Office Action Summary

10/563,993

REICHENBACH ET AL.

DETAILED ACTION

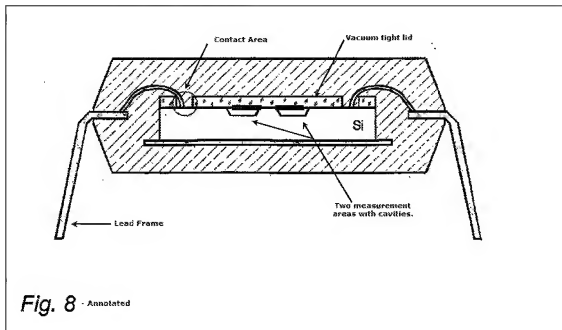
With respect to Claims 19, 20, and 31, Landsberger discloses an apparatus comprising:
a measurement chip (the Si substrate) with a first and second measurement area/structure formed thereon (the cantilever structures);
the measurement areas being offset in a lateral direction;
a cap chip fastened to the measurement chip in a connecting area;
intermediate space (the cavity) between the cap chip and the measurement chip; and
at least one contact area not covered by the cap chip. See Annotated Fig. 8 below;
Abstract; & ¶s 43, 51-54.

With respect to Claim 21, 25, and 27, Landsberger discloses two contact areas formed on opposing sides of the measurement chip and left exposed by the cap chip. See Annotated Fig. 8 below.

With respect to Claim 35, Landsberger discloses a lead frame, a housing, and wire bonds. See Annotated Fig. 8 below. (Compare to Applicant's Fig. 8).
